AALSETH

06-18-19

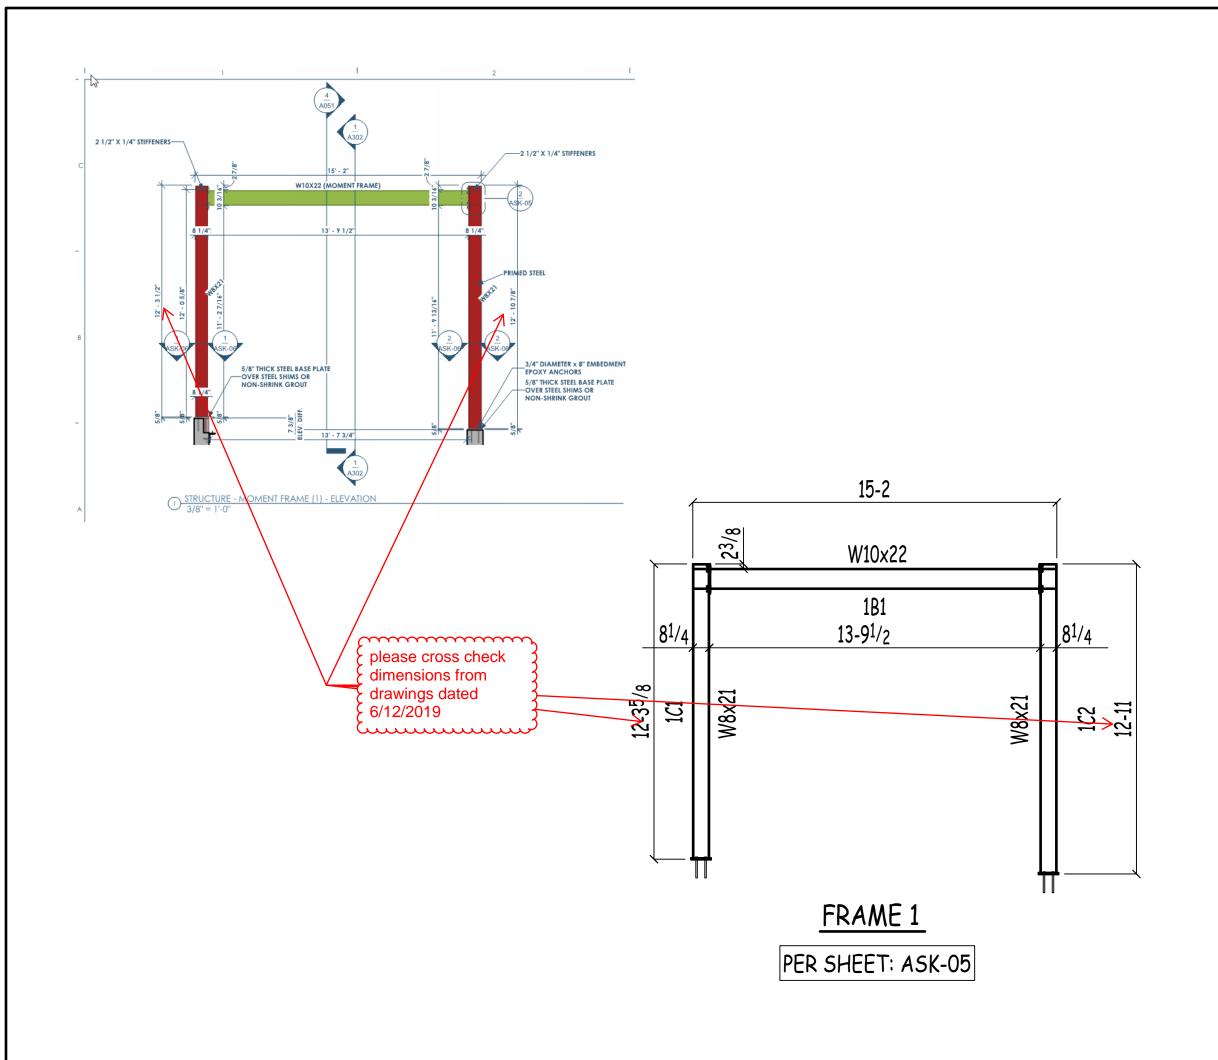
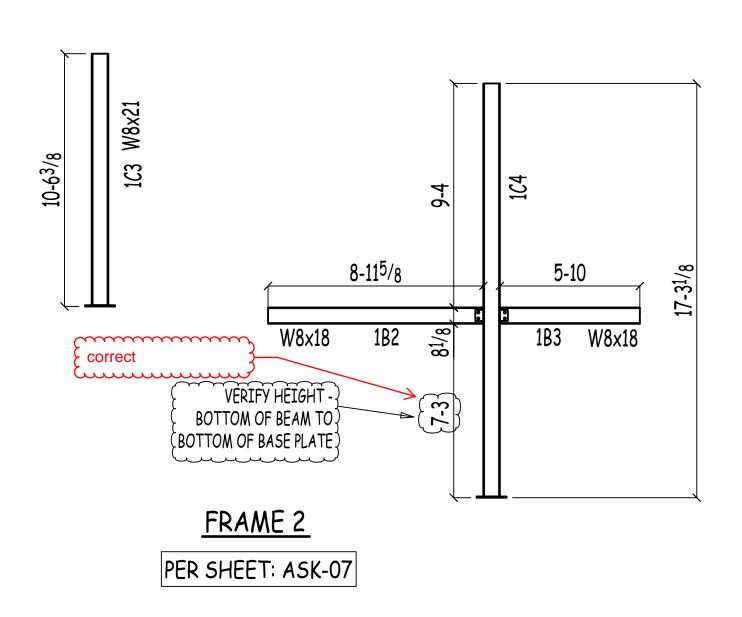
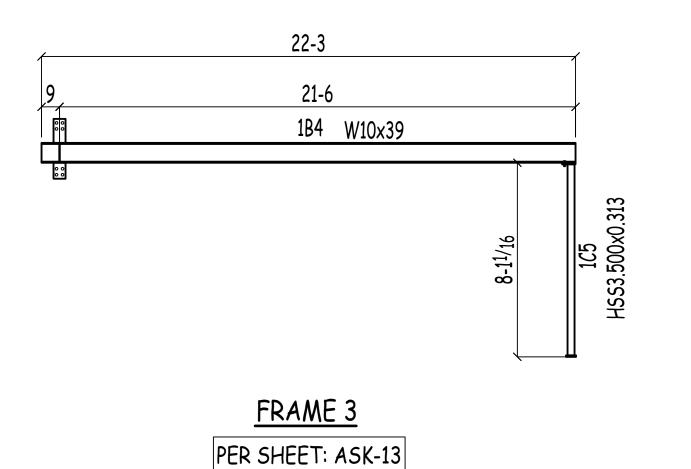
{ Is 15/16" dia. hole industry standard for 3/4" { holts?

{ I'm leaning toward 13/16" instead. Can you please call/email your thoughts.

If you don't see 13/16" being a problem, let's do that throughout the set.
